AGENDA
TECHNICAL REVIEW COMMITTEE (TRC)
April 1, 2025
10:00AM

RE: COATES DIXIE ROW VACATE (HALFF AVO 043866.158)
REVIEW #1

SKETCH FOR DESCRIPTION
(NOT A FIELD SURVEY)

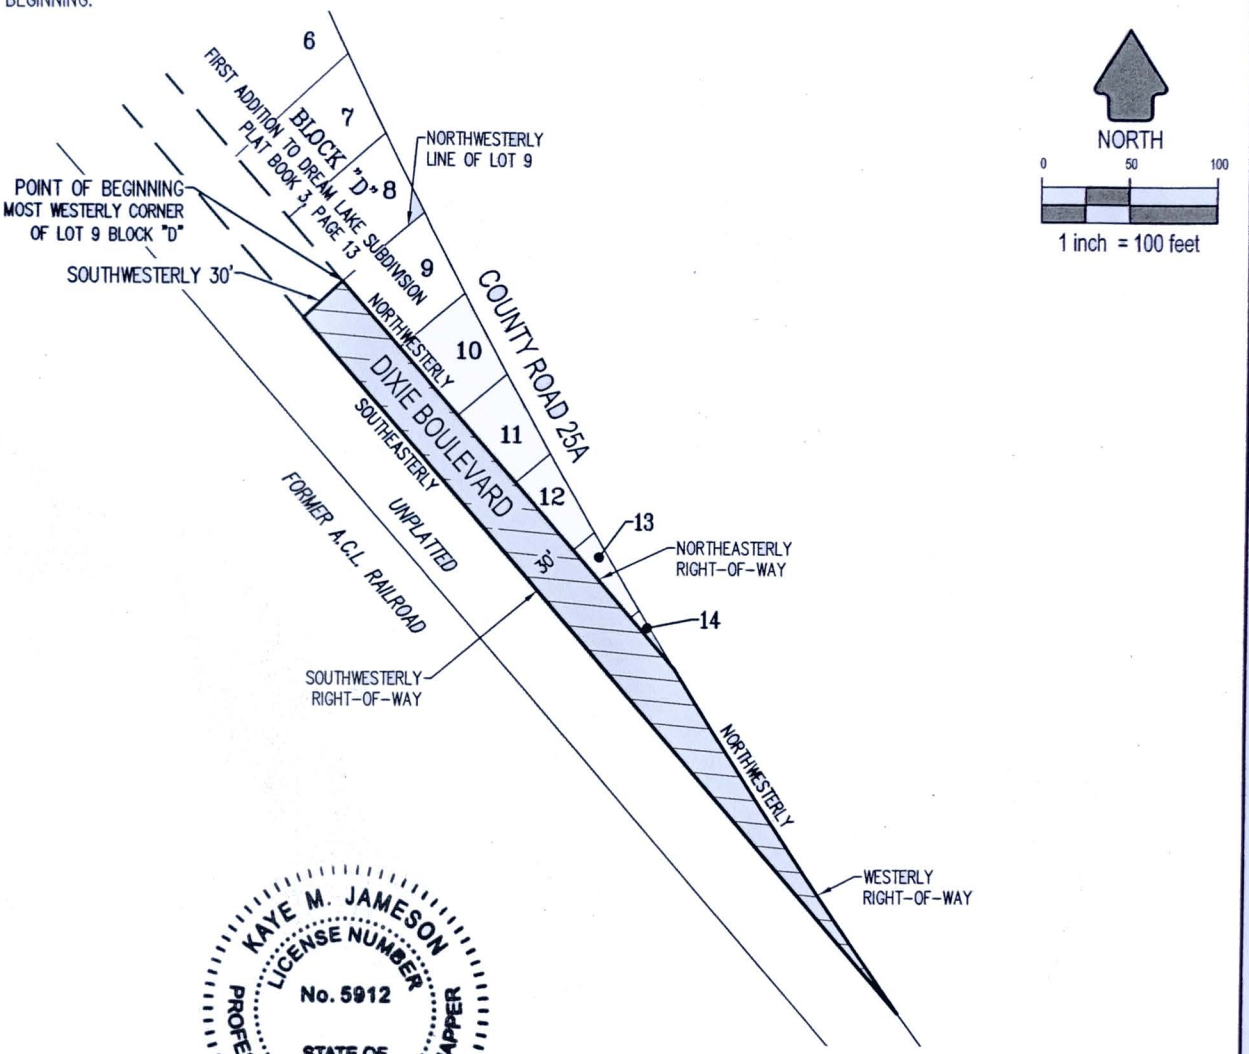
1. What utilities are within this right-of-way? How was this determined?
2. Survey submitted is not legible and appears to be from 2016. Updated signed/sealed survey should be provided.

1. There must be a description of the right of way to be vacated, either by metes and bounds or by bounding calls, along with at minimum a sketch depicting the area of vacation.
2. The vacation must go through the process of being advertised in the newspaper, utility providers being notified of the proposed vacation, surrounding property owners being noticed. If no objections, then resolution by City to formally vacate.

MASTER SITE PLAN & SITE DATA

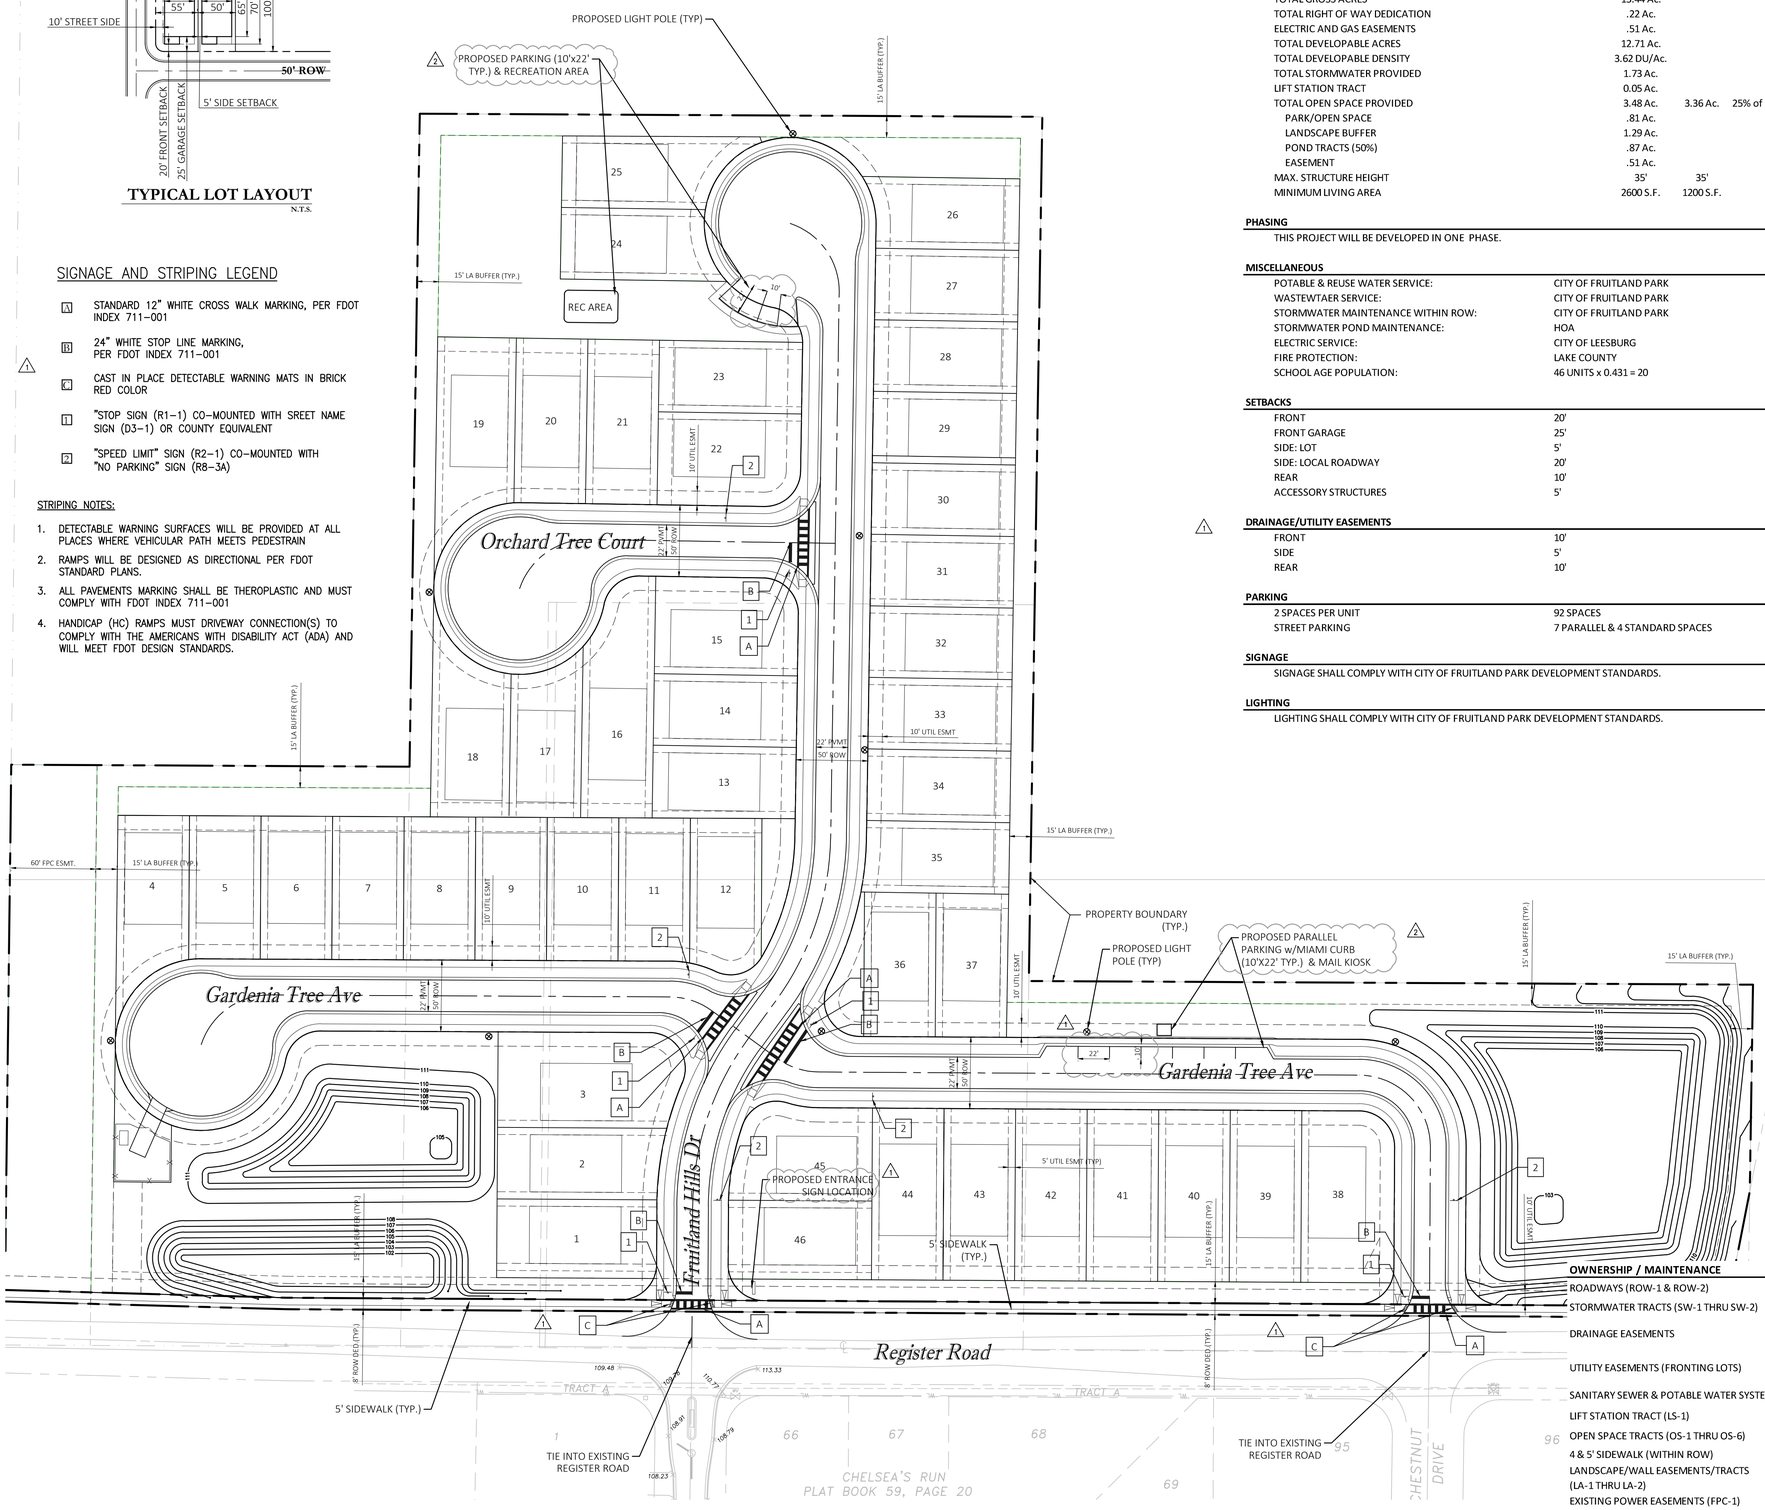
Repumping the sanitary will require a generator. They have a generator pad shown on the lift station site plan, and note 27 clearly states that a generator must be provided, so it looks like we are covered.

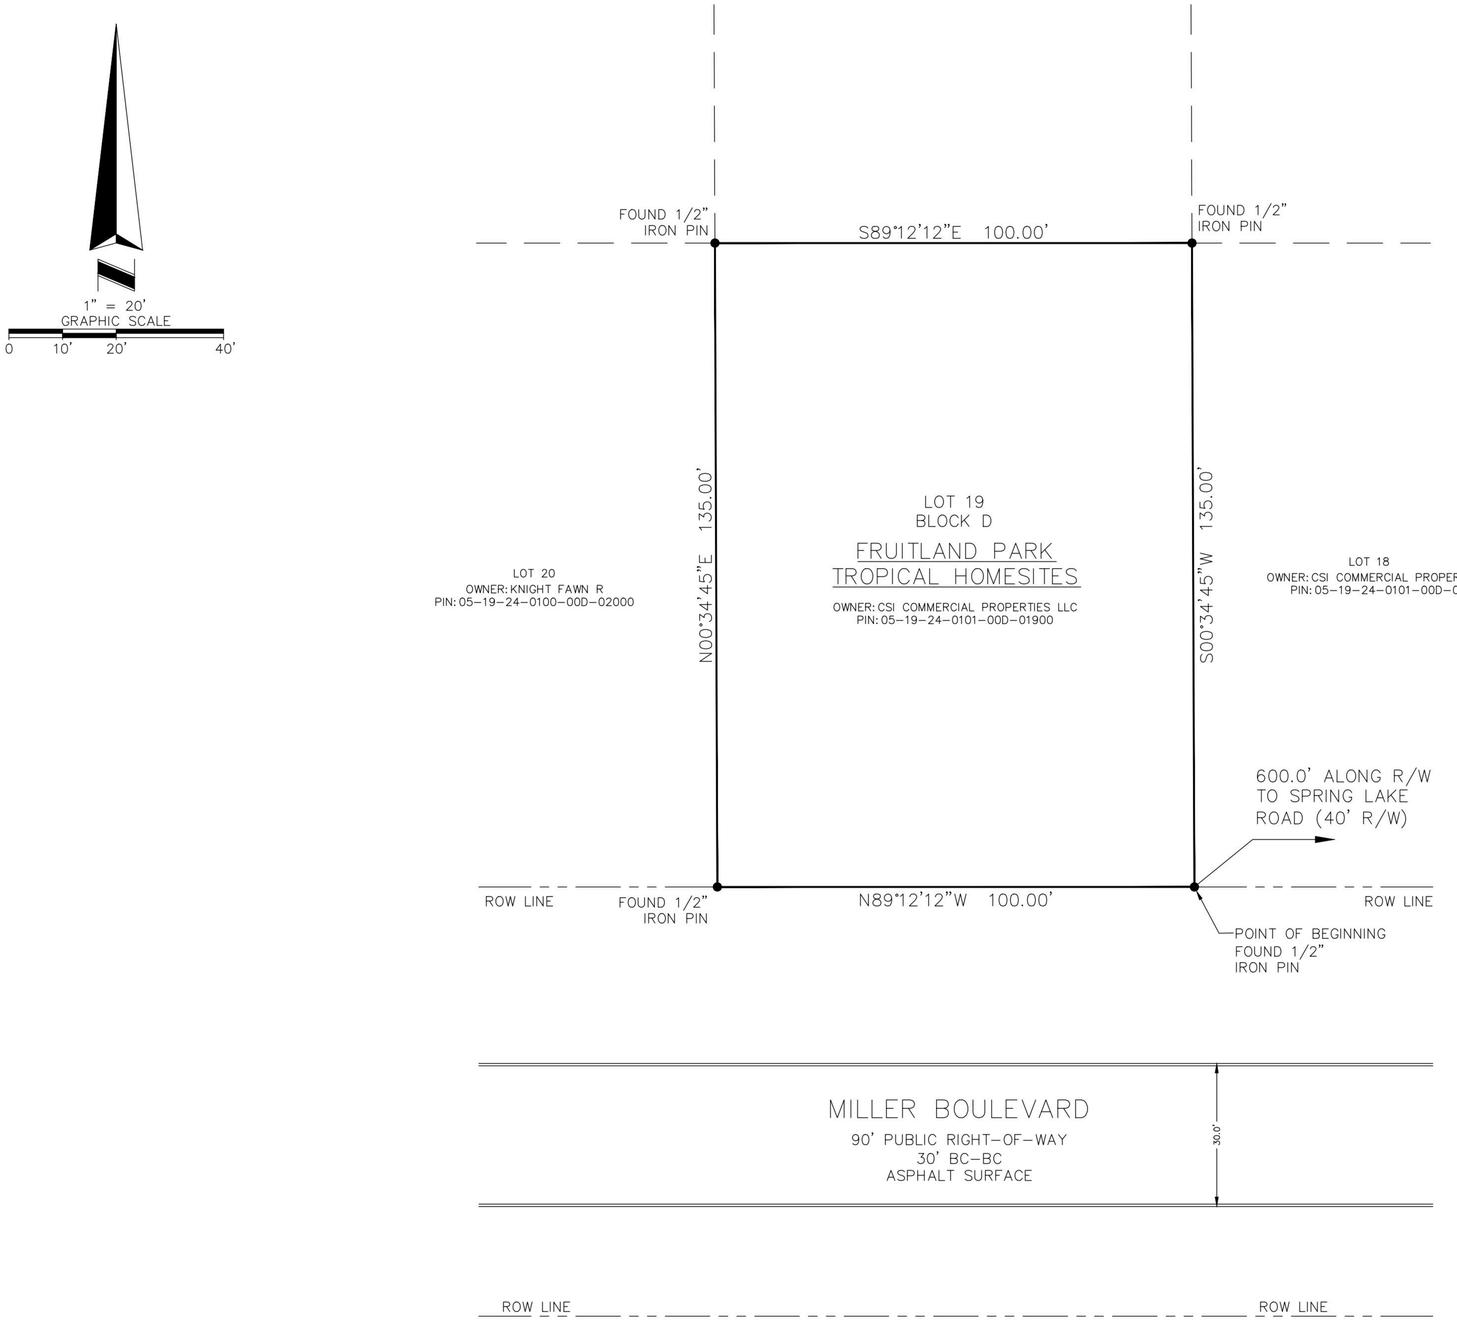
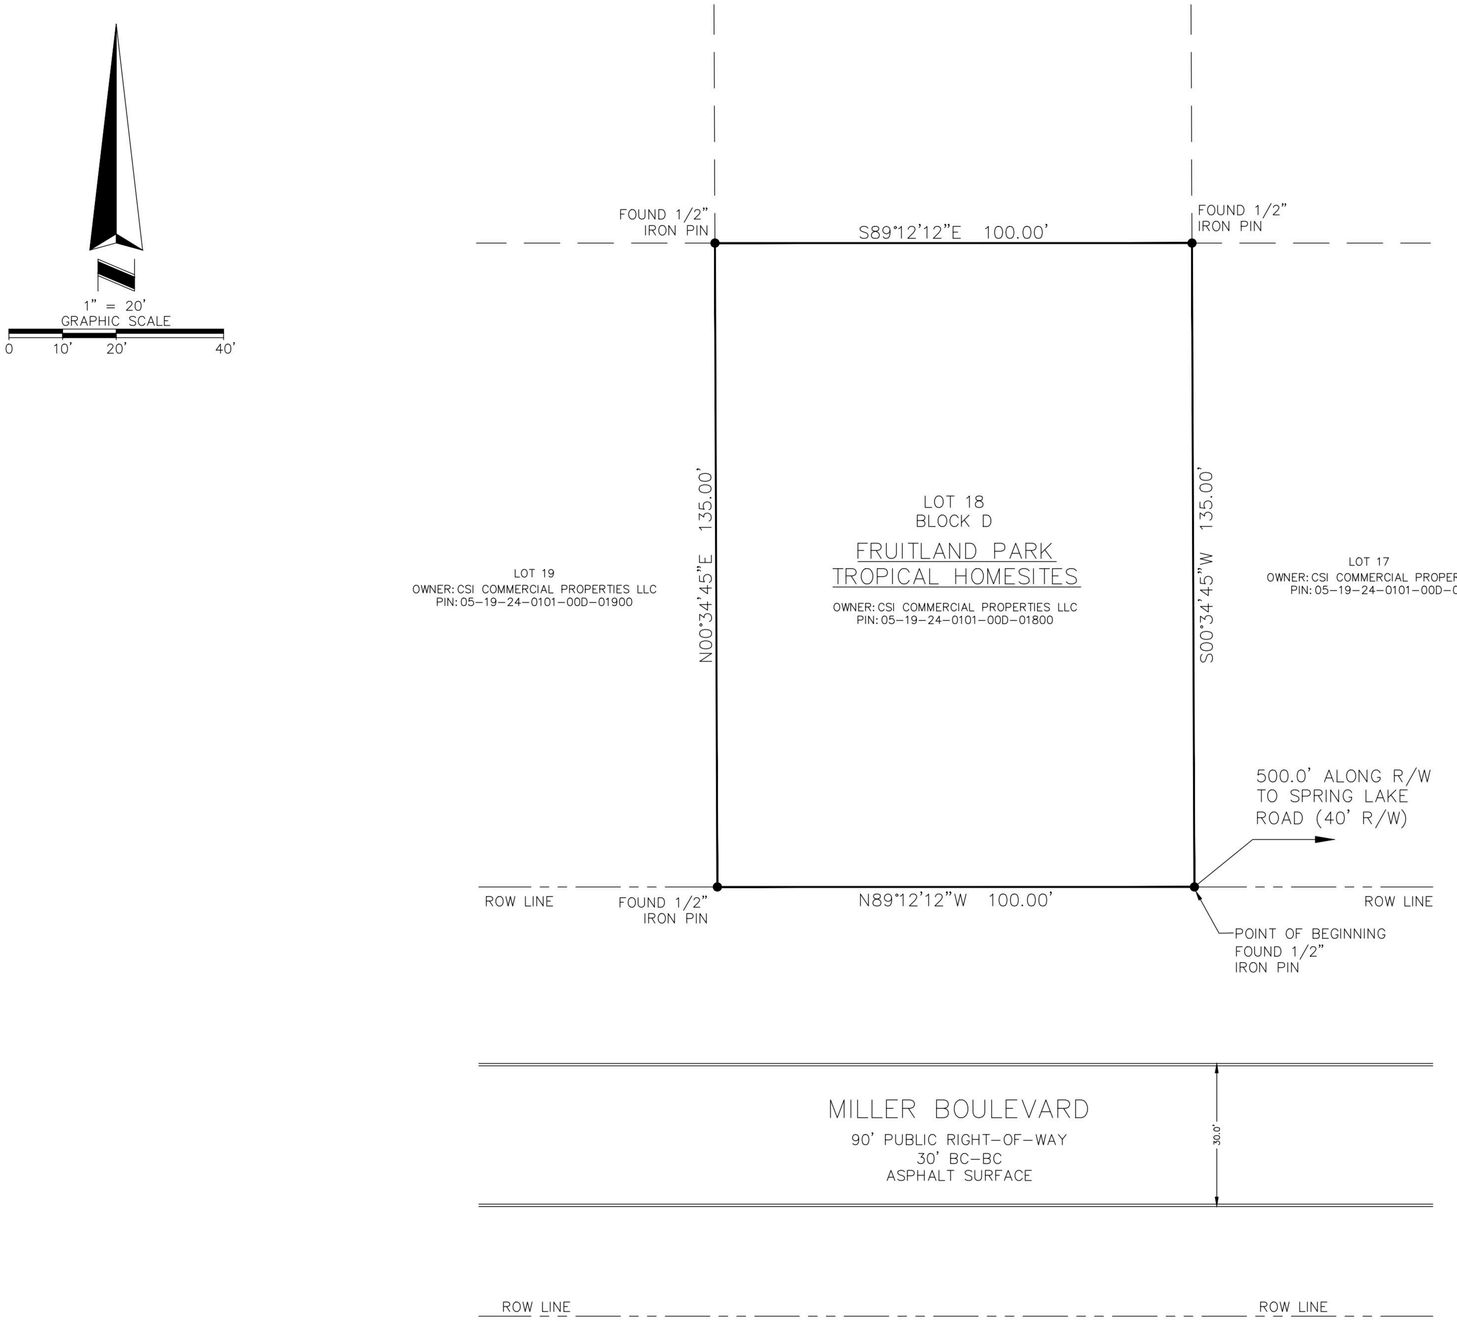
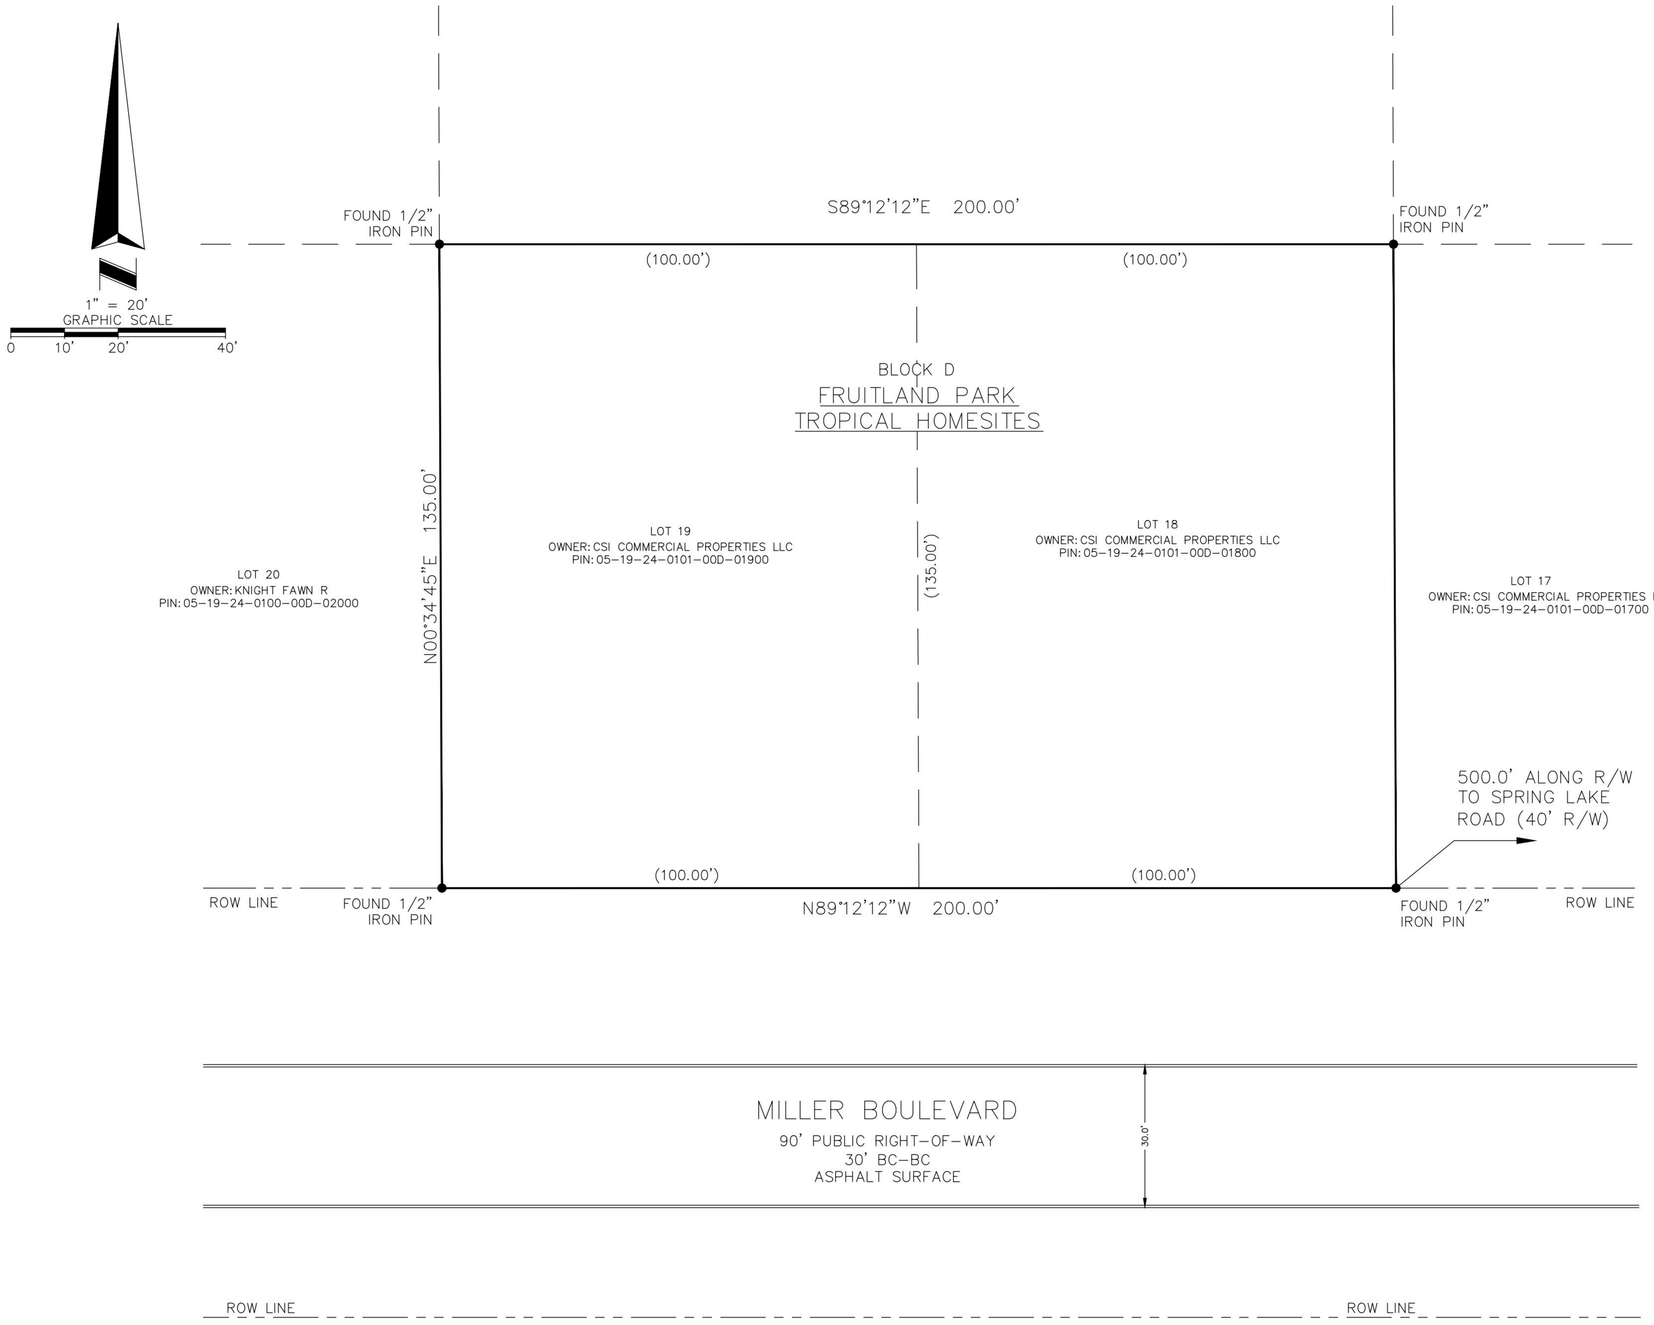
1. Three (3) drawings were provided in the package but none of them are Boundary Surveys.
2. Please provide three (3) **certified** Boundary Surveys (one for Lot 18, Block D, one for Lot 19, Block D and one for Lots 18 & 19, Block D combined).
